Technical Note

2012:55

Review of SKB's Radionuclide
Transport Methodology

As part of SSM's Initial Review Phase of SKB's SR-Site safety assessment of the final disposal of spent nuclear fuel at the Forsmark site, Quintessa has been requested by SSM to consider whether SKB's methodology to abstract FEPs (features, events, processes), as well as site information and other data, into assessment models for radionuclide transport is appropriate and sufficient for its purpose. This Technical Note summarises the findings of Quintessa's review.

Figure 1: The three fracture flow cases considered (reproduced from TR-10-50 Figures A-2 and A-5).

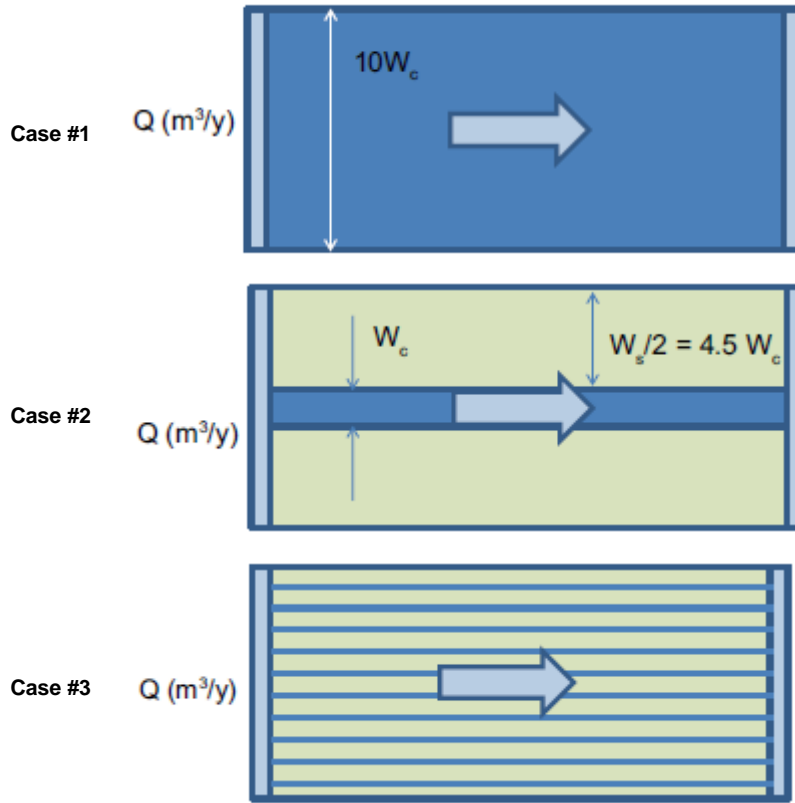
17. Appendix A.2, 2nd para: W_s is reported as being the half width of the total stagnant zone, i.e. 4.5 times the width of the flow channel. In Figure A-2, it is indicated as being the full width of the total stagnant zone, i.e. 9 times the width of the flow channel. Which is correct? Note that it was found

Note that there are conflicting definitions of W_s in the SKB report. In the second paragraph of page 199 it is reported as being the half width of the total stagnant zone, i.e. 4.5 times the width of the flow channel. In Figure A-2 (reproduced here in Figure 1) it is indicated as being the full width of the total stagnant zone, i.e. 9 times the width of the flow channel. It was found that the SKB calculations could only be matched if the former definition is used.

Figure 4: CDF of residence time in fracture for a weakly-sorbing species (independent calculations) showing the effect of varying the base case F-factor on Cases #1 (whole fracture; lines) and #2 (single channel with stagnation zone; symbols).

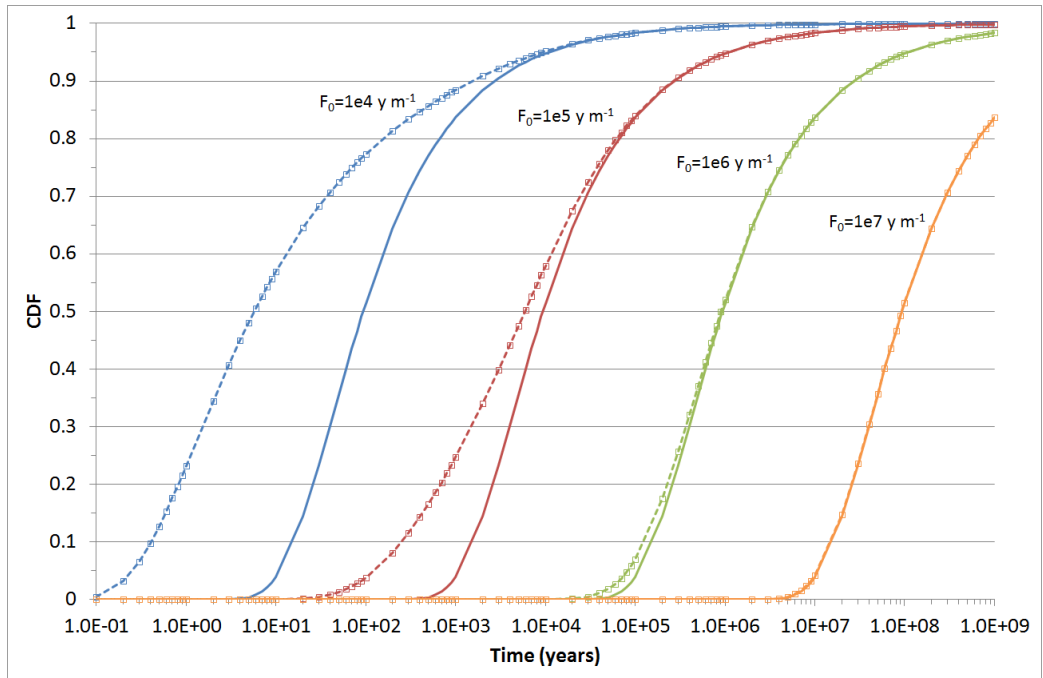
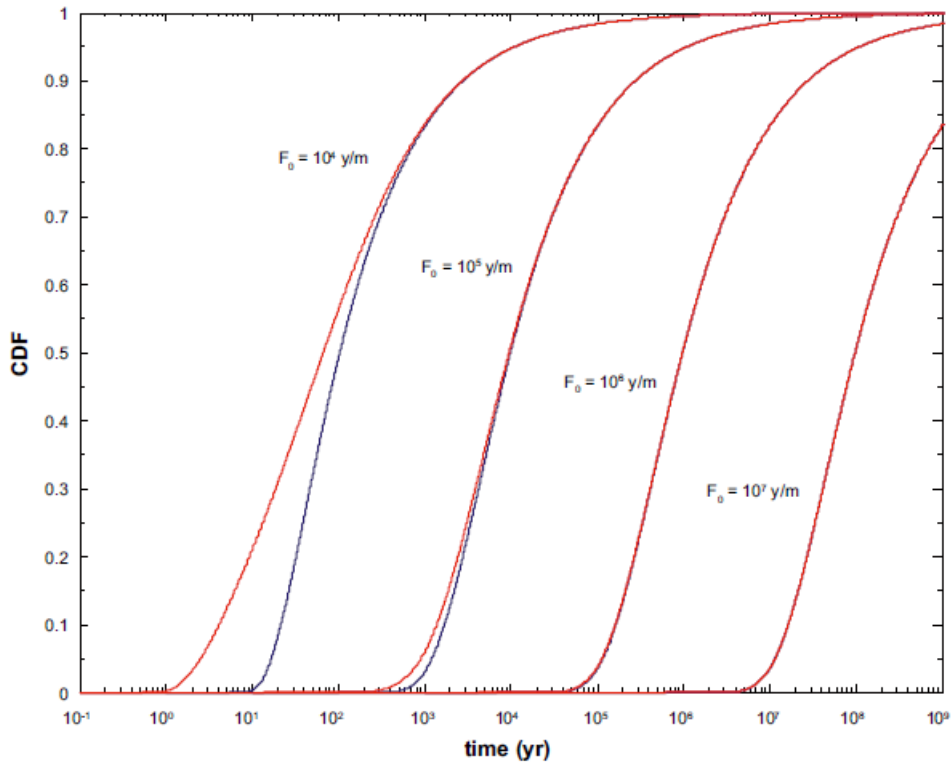
19. Why is the gap between the Case 1 and Case 2 results on Figure A-7 larger than the two cases (1E5 and 1E6) that should bound it on Figure A-9?
20. Appendix B: This contains many small discussions and calculations relevant to retention properties. It is unclear whether these issues have been taken into account in the data report. How does it relate to the Kd discussions in the data report?

The same parameterisation was used for these calculations as for the previous set, but it was found that the results for Case #2 did not match those reported by SKB (reproduced here in Figure 5). In the independent calculations there is a larger difference between the Case #1 and Case #2 curves, particularly evident for the smaller F-factors. Although not stated in the text, it is possible that another parameter apart from F_0 was altered for these calculations; this parameter would have to play a role in the stagnant zone diffusion term alone since the Case #1 curves match well. This suggestion is supported by the fact that the gap between the Case #1 and #2 curves in Figure A-8 (reproduced as Figure 5) for $F_0 = 1\text{E}5 \text{ y m}^{-1}$ appears to be smaller than that between the same curves for $F_0 = 5\text{E}5 \text{ y m}^{-1}$ shown in Figure A-3 (reproduced here as Figure 2), bucking the trend that the difference between the two cases diminishes as the F-factor increases. The effect is even clearer if Figures A-7 and A-9 are compared.

However, despite this anomaly the independent calculations support SKB's conclusions that the effect of an early breakthrough time promoted by channelling is diminished as the F-factor increases.

Figure 6: CDF of residence time for a strongly-sorbing species (independent calculations), showing the effect of varying the base case F-factor on Cases #1 (whole fracture; lines) and #2 (single channel with stagnation zone; symbols and dashed lines).

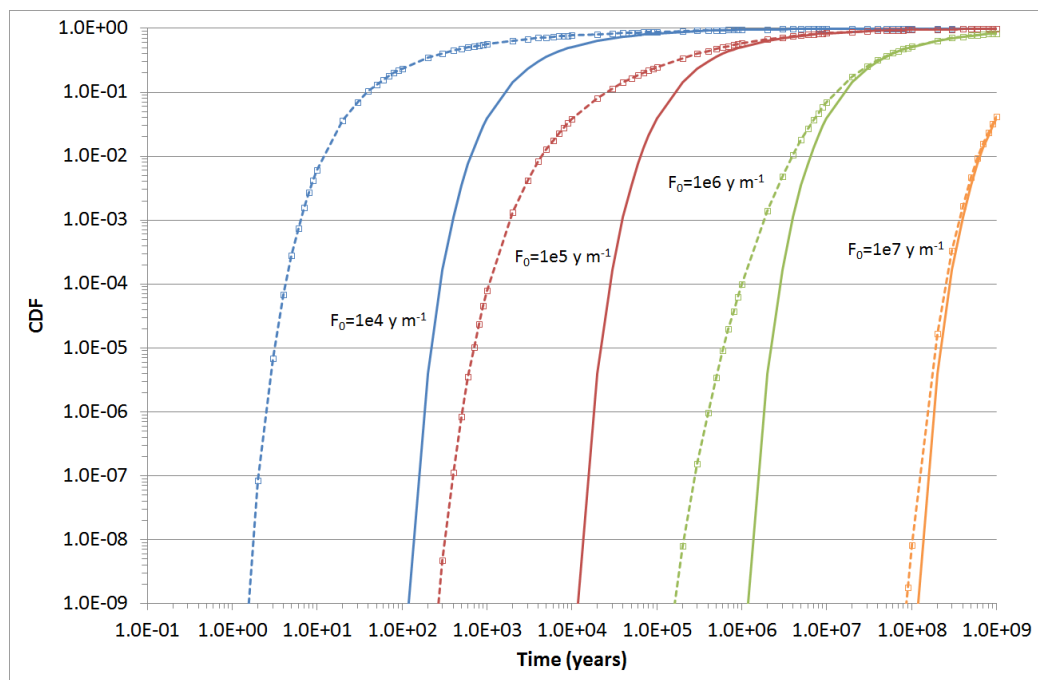
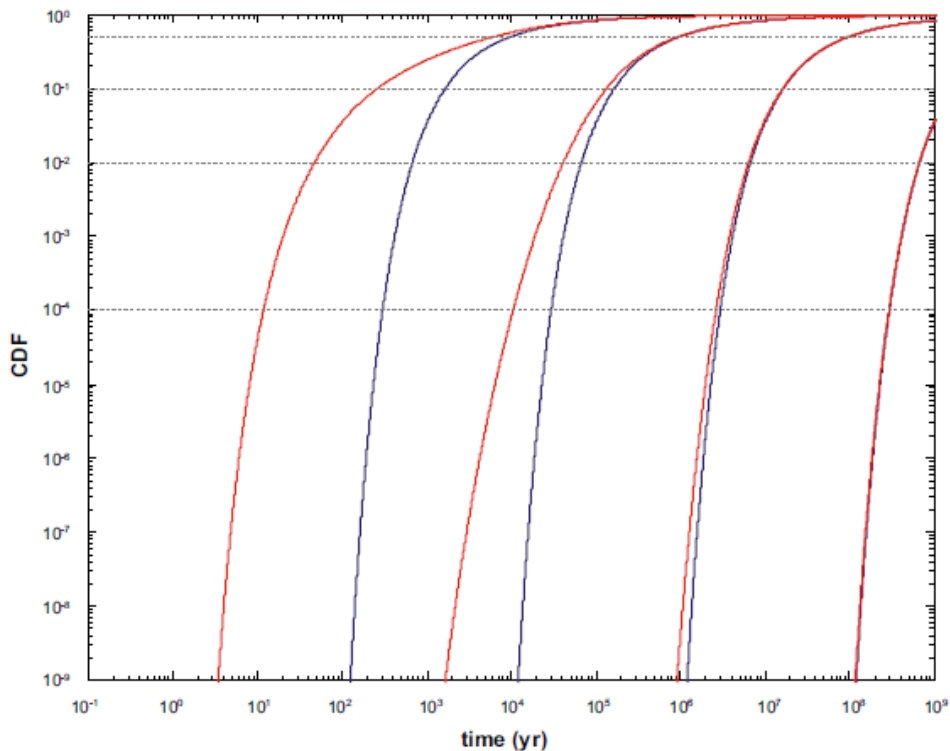
The independent calculations were parameterised (except for the K_d and F-factor) in exactly the same manner as the previous calculations, but once again do not match the original SKB calculations shown in Figure A-10 (reproduced here in Figure 7). Without being sure of the input parameters used by SKB, it is impossible to say whether these differences are due to parameterisation or calculation errors, although the former is the more likely.

Figure 9: Scatter plot showing how the amount of Th-230 in solution at the pinhole varies with the solubility limit of Th.

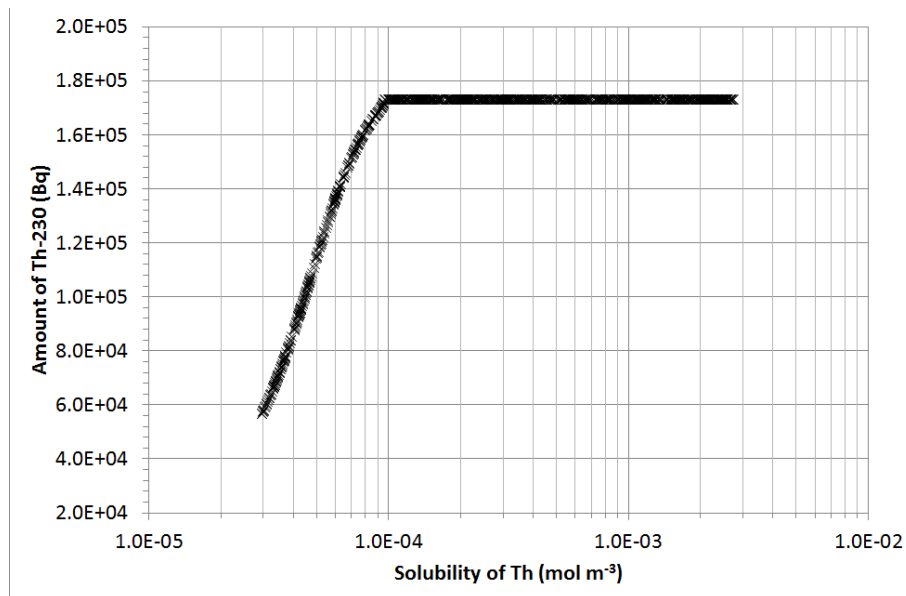
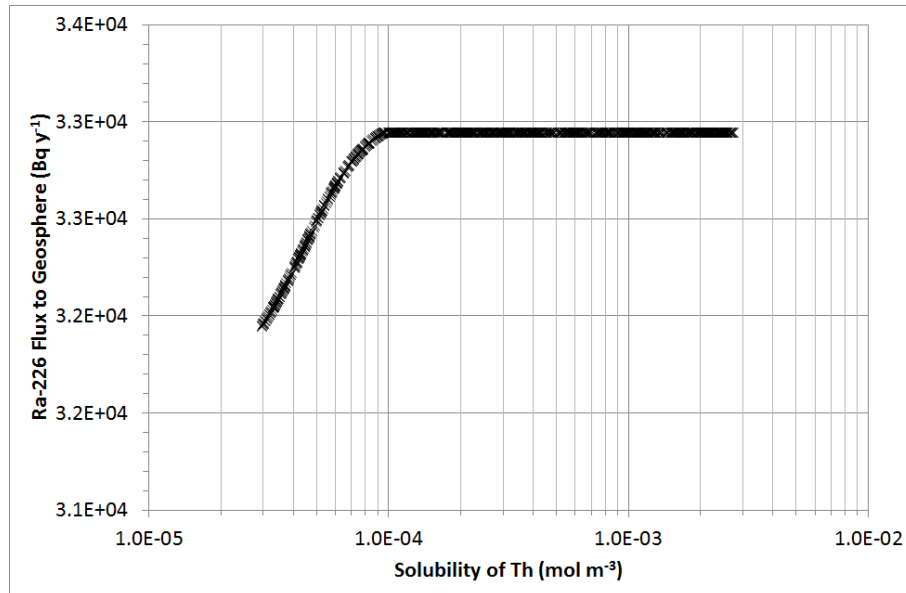
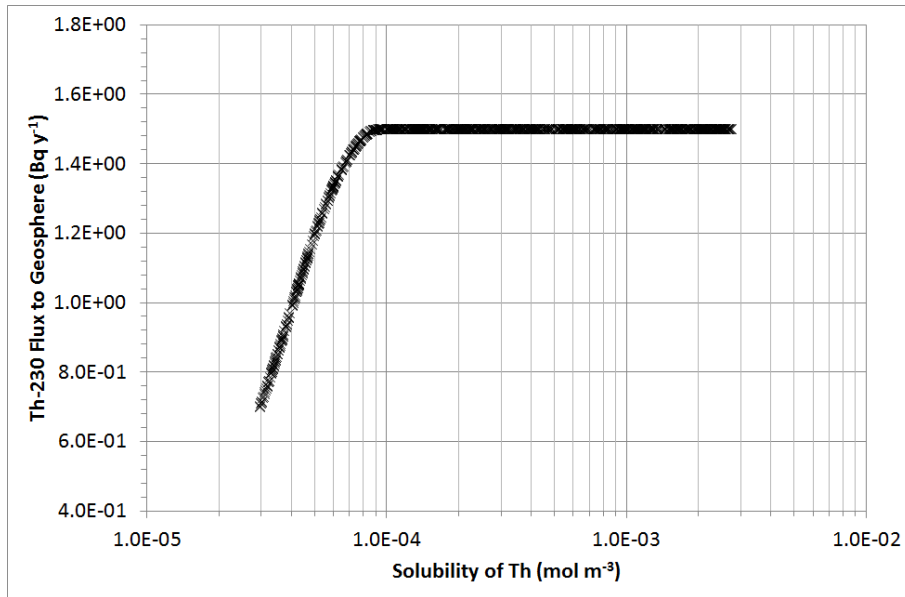
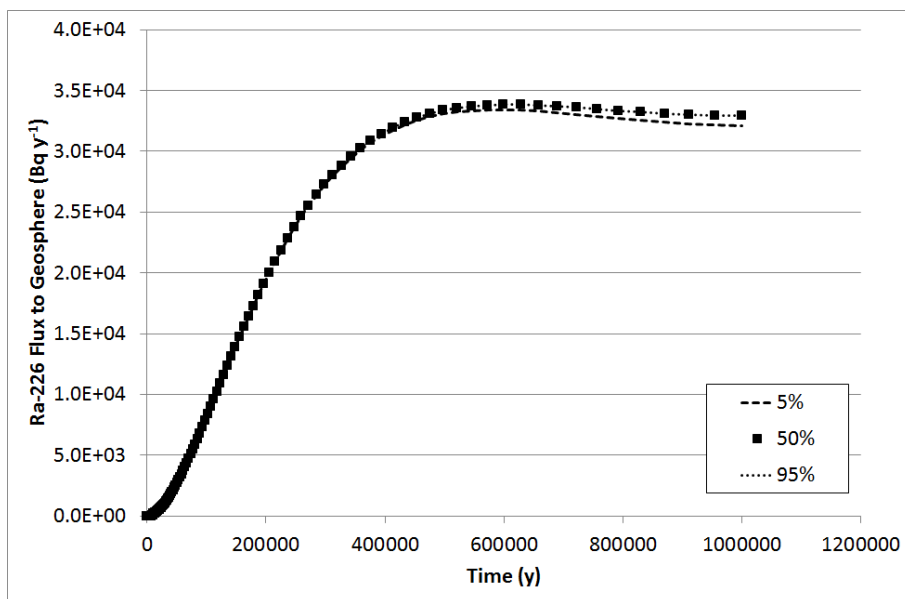
As expected, the independent calculations show that the amount of Th-230 in solution at the pinhole increases with the solubility limit, as demonstrated by the scatter plot shown in Figure 9. This plot also shows that, for solubilities larger than approximately $1\text{E-}4 \text{ mol m}^{-3}$, a balance is achieved between the dissolution of

Th-230 and the transport of the radionuclide away from the canister. This threshold point is almost an order of magnitude smaller than the best estimate solubility limit for thorium.

The equivalent plot for Ra-226, Figure 10, shows a reverse effect; as the solubility of Th-230 increases and it becomes more mobile, the amount of the more soluble Ra-226 in solution at the pinhole reduces (until the threshold point at which the balance is struck between dissolution and transport).

Indeed, a correlation between the solubility limit of Th and the flux of Ra-226 leaving the buffer and entering the geosphere can clearly be seen in Figure 12. However the two parameters are not correlated in the manner that might be expected; a smaller solubility limit and hence immobilisation of Th-230 leads to a reduced flux of Ra-226 at the buffer/geosphere interface, despite the fact that there is more Ra-226 available for transport immediately adjacent to the fuel.

Thus it would appear that the effect of Th-230 immobilisation and ingrowth of Ra-226 near the fuel is insignificant compared to the ingrowth of Ra-226 along the path that the mobile Th-230 takes through the buffer to the geosphere. This is further demonstrated by the fact that a similar correlation can be seen between the flux of Th-230 itself to the geosphere and the solubility limit, as shown in Figure 13. The two effects of immobility of thorium (greater ingrowth of Ra-226 near the canister and reduced flux of Th-230 through the buffer leading to less ingrowth there) work to negate each other, meaning that the overall impact on the flux of Ra-226 is small (Figure 11). Conversely, the overall impact on the flux of Th-230 is larger, as shown in Figure 14.

Figure 15: The flux of Ra-226 from the geosphere against time, for the extreme cases of no Th sorption (dashed line); no Th solubility limit (symbols); and a Th solubility limit of 0 mol m^{-3} (dotted line). The base case result is also shown (unbroken line).

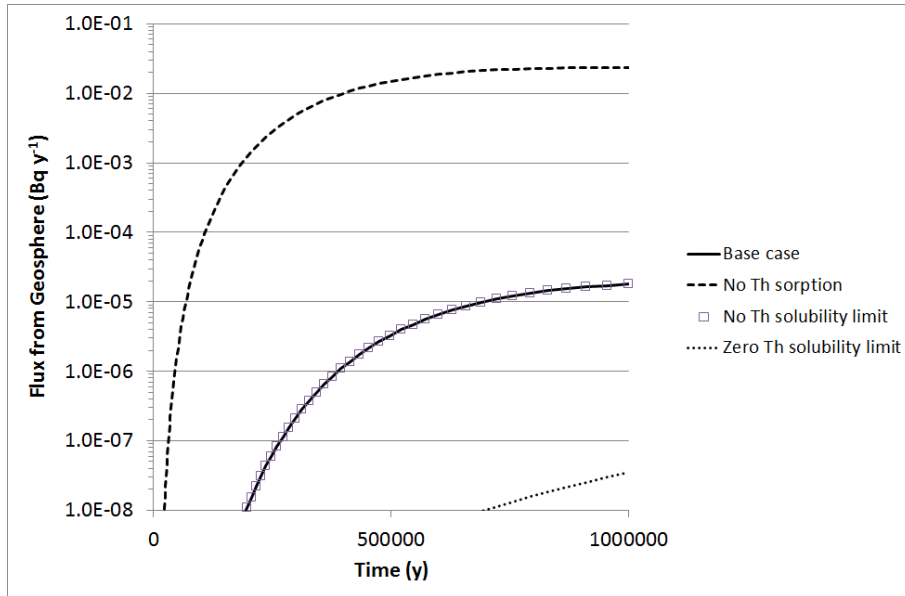
The importance of sorption of thorium in the buffer is underlined by considering the extreme cases of no solubility limit (i.e. an essentially infinite limit) and no sorption of thorium in the bentonite. The flux of Ra-226 leaving the geosphere for each of these cases is shown in Figure 15 along with the results from the deterministic base case. If there is no sorption of Th in the buffer, the resultant flux of Ra-226 is over three orders of magnitude larger than the base case over the timescales considered by SKB. Conversely, if the solubility of Th is essentially unlimited but sorption is included in the model, there is little difference between the resultant flux and the base case flux. This is as expected in light of the previous results presented, since

the base case solubility limit already lies in the region where there is a balance between the dissolution of the fuel and diffusion away from the canister.

Also included in the figure are the results from another extreme case, this time with a zero solubility limit for thorium, which has the effect of confining Th-230 to the canister. This results in a very small flux of Ra-226 from the geosphere over the timescales considered, since all the contribution must come Ra-226 ingrowing in the canister and then making its way through the buffer.

Figure 16: Flux of Ra-226 to the geosphere plotted against time, for the base case and a case with a thinner buffer.

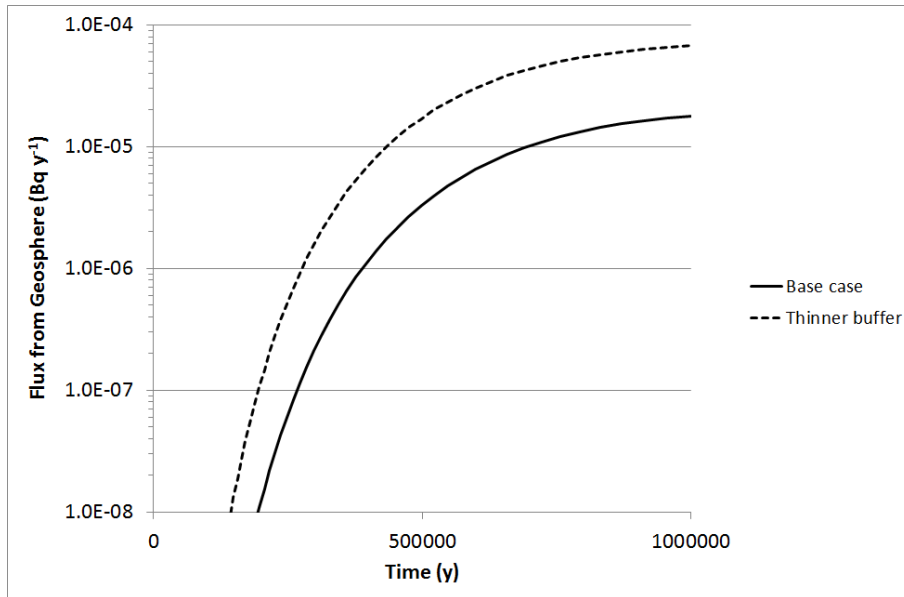
The results presented are for an intact buffer case, and demonstrate that solubility limits (within the range of suggested values) are not an important constraint on the flux of Ra-226 to the biosphere, but that sorption in the buffer does play an important role.

If the buffer thickness is reduced, as in the shear failure case, then this ability to sorb Th-230 is reduced and the flux of Ra-226 from the geosphere increases accordingly as shown in Figure 16.
